GEORGE HALL MPR AND SUPPORT ROOMS PROJECT #19-143

ADDENDUM NO. 2

Date: November 19, 2021

Project: #19-143 George Hall MPR and Support Rooms Project
DSA #: 01-119574 41-26

SHEET NAME:
BUILDING SECTIONS

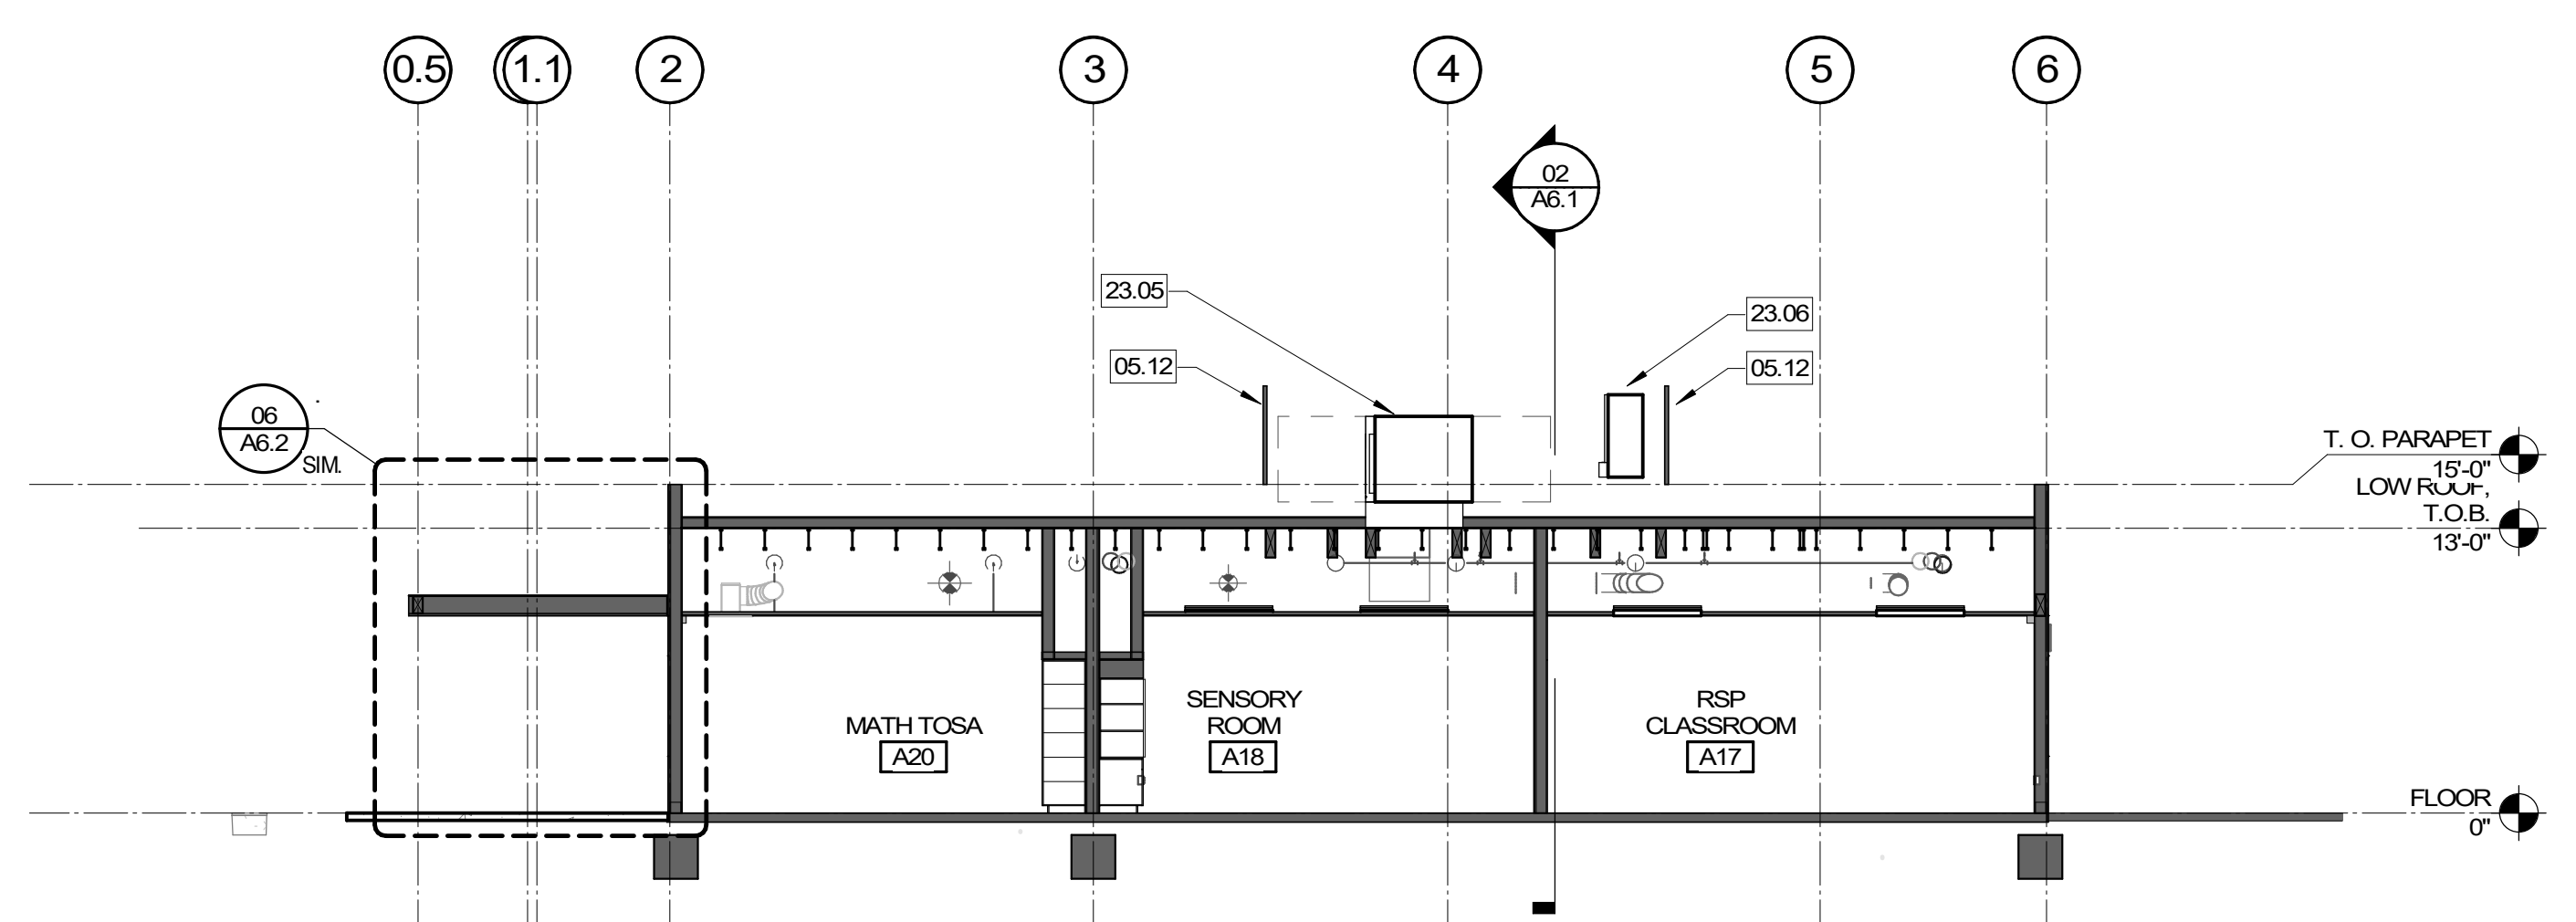
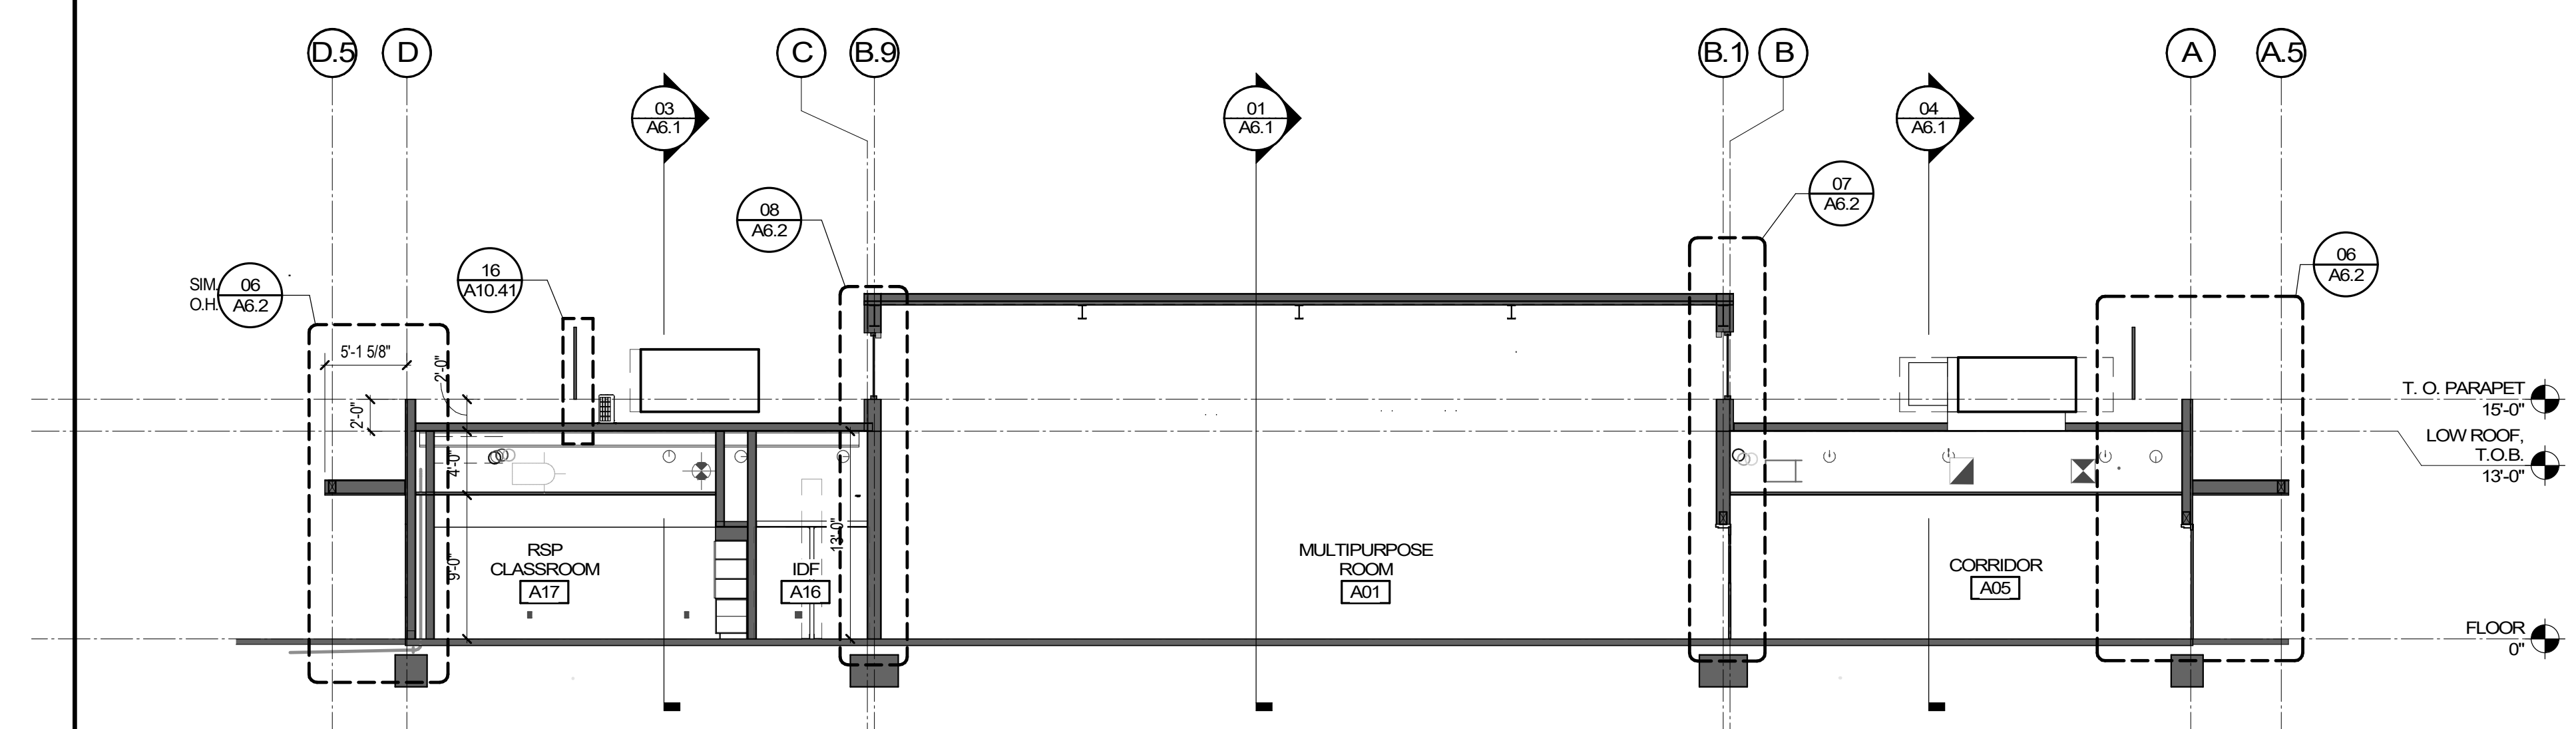
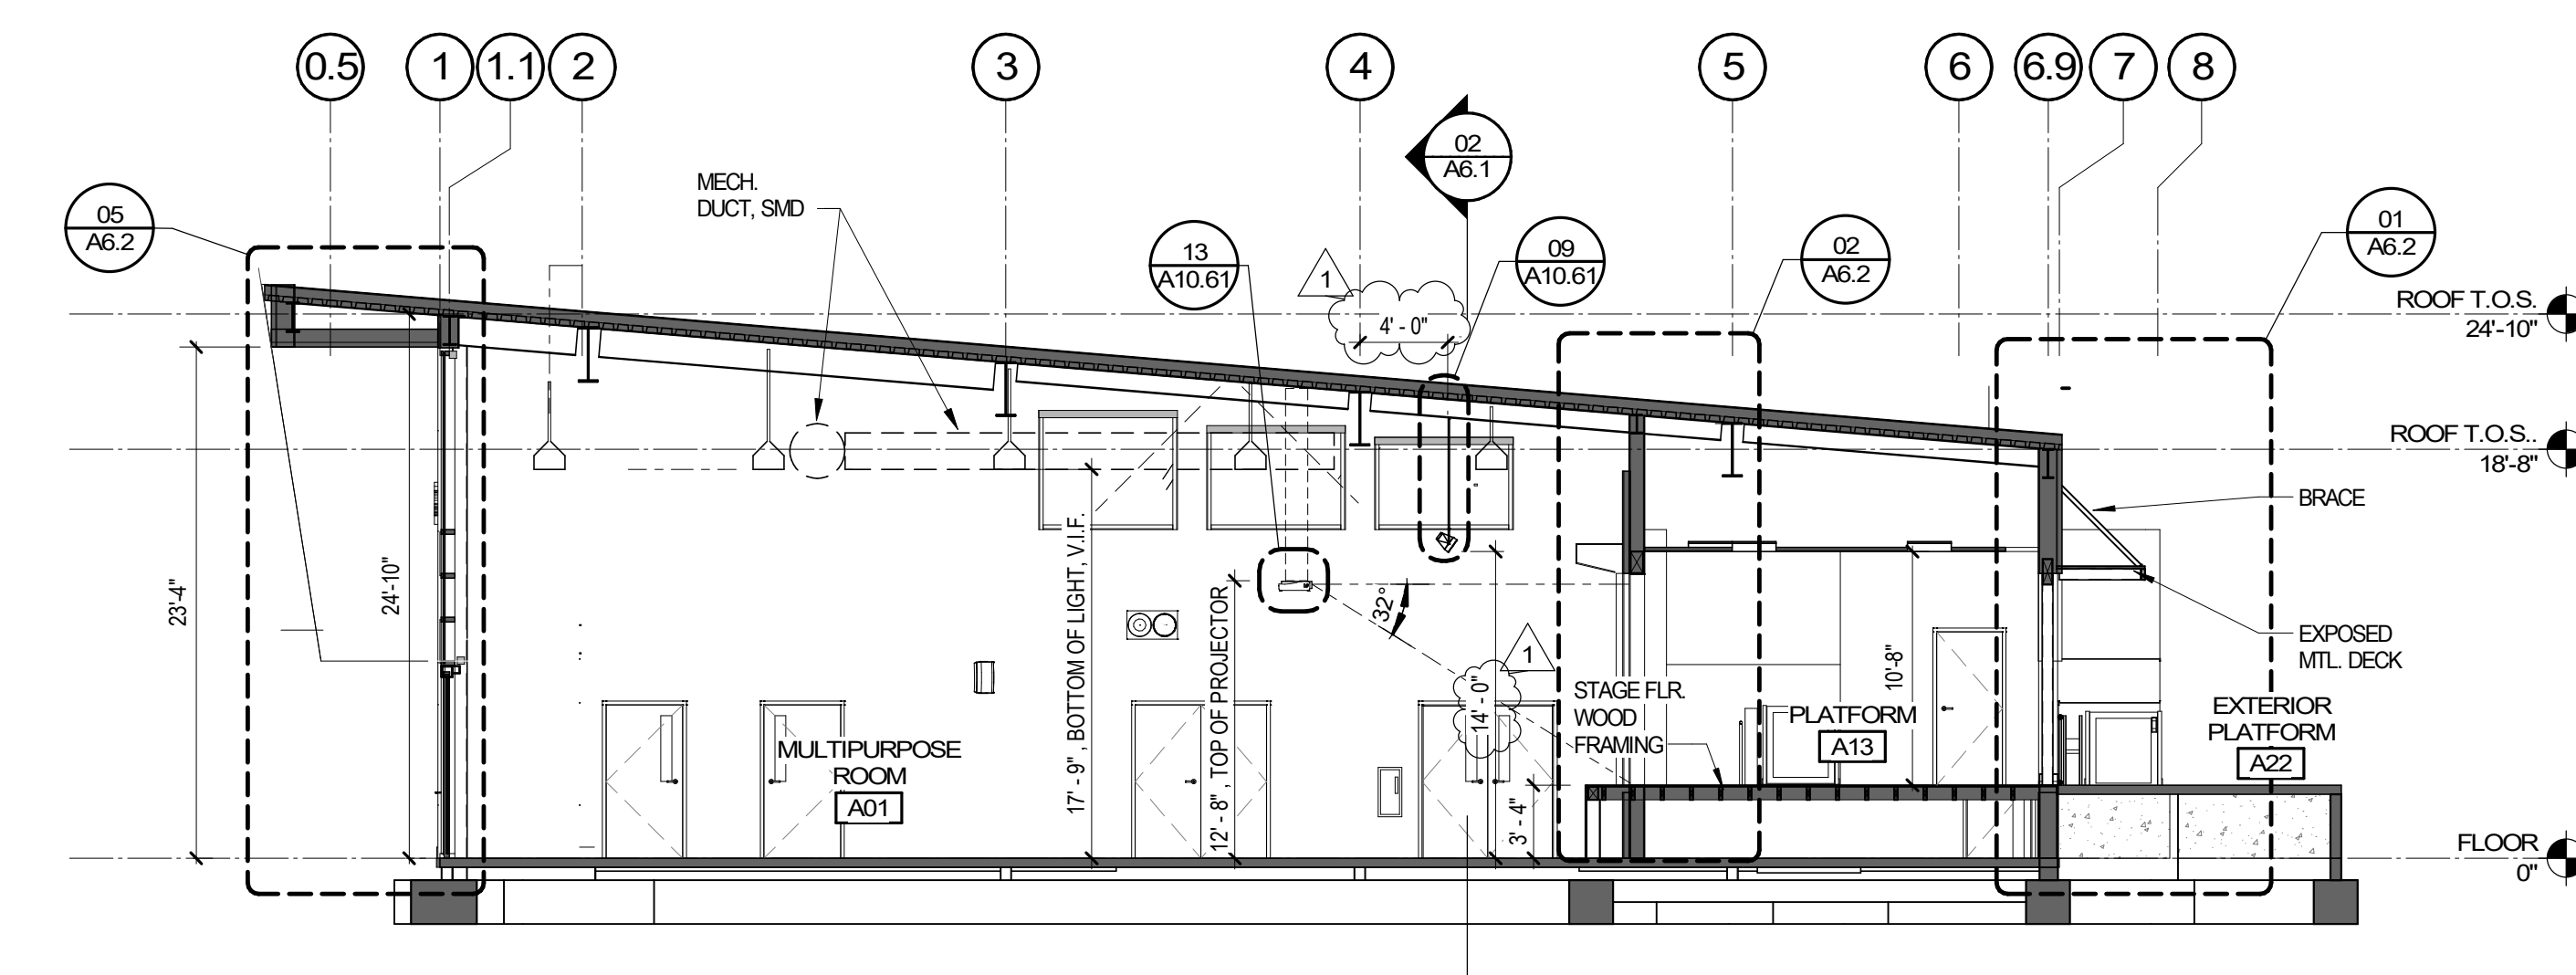
A. Added some dimension for placement of lights.

STAIR & WHEELCHAIR LIFT PLAN 06
1/2" = 1'-0"

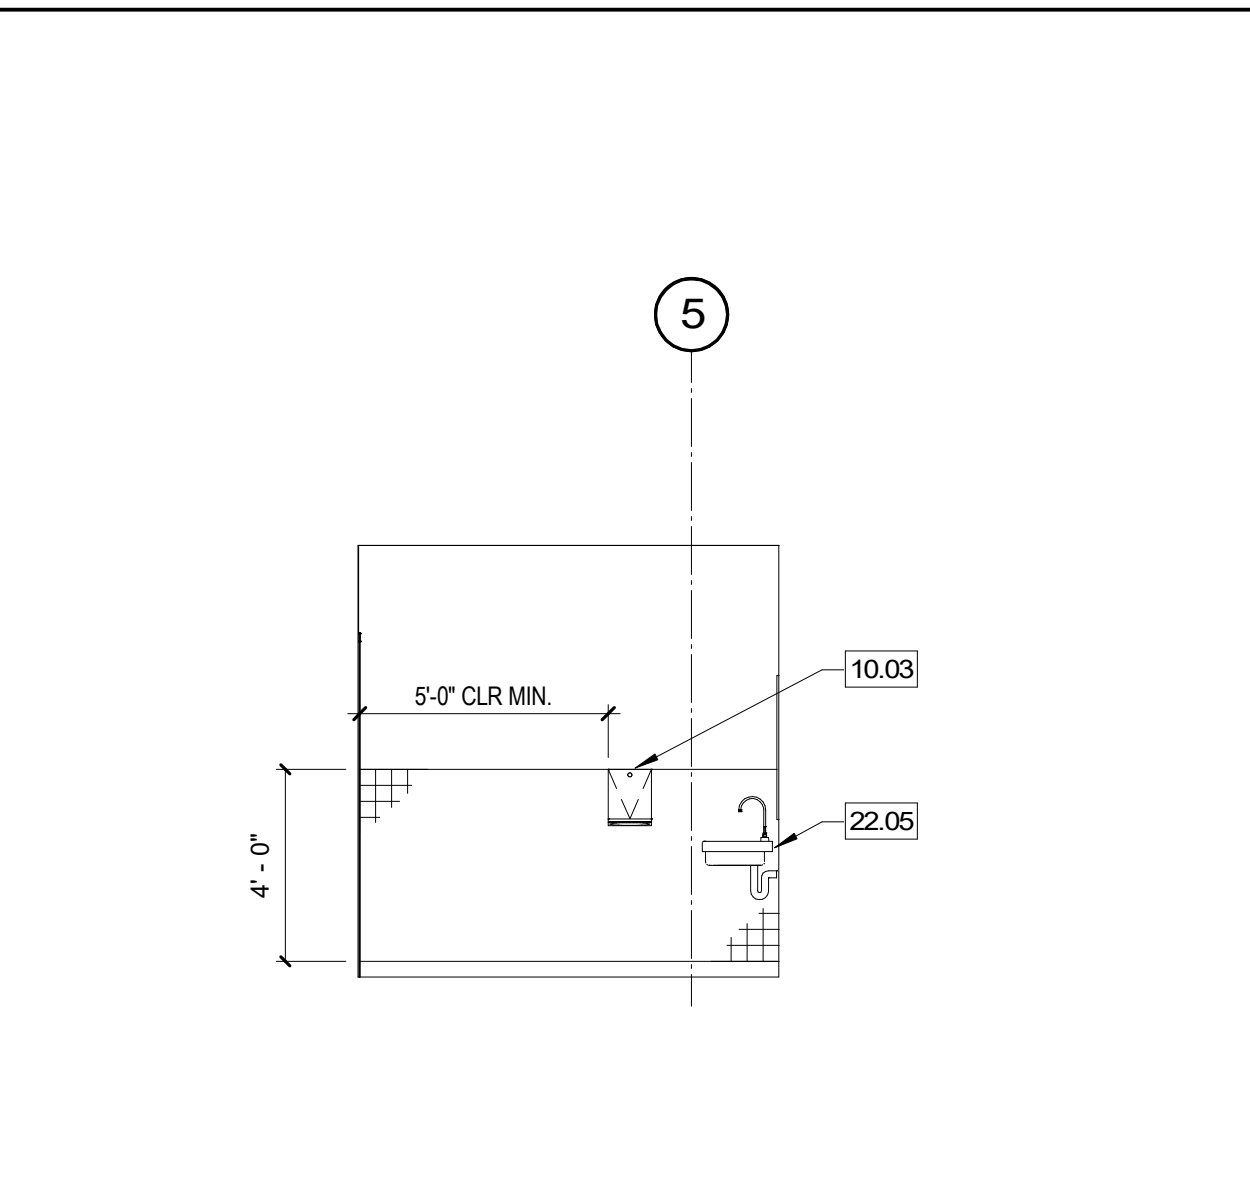
A. Added some layout dimensions to 06/A7.1.
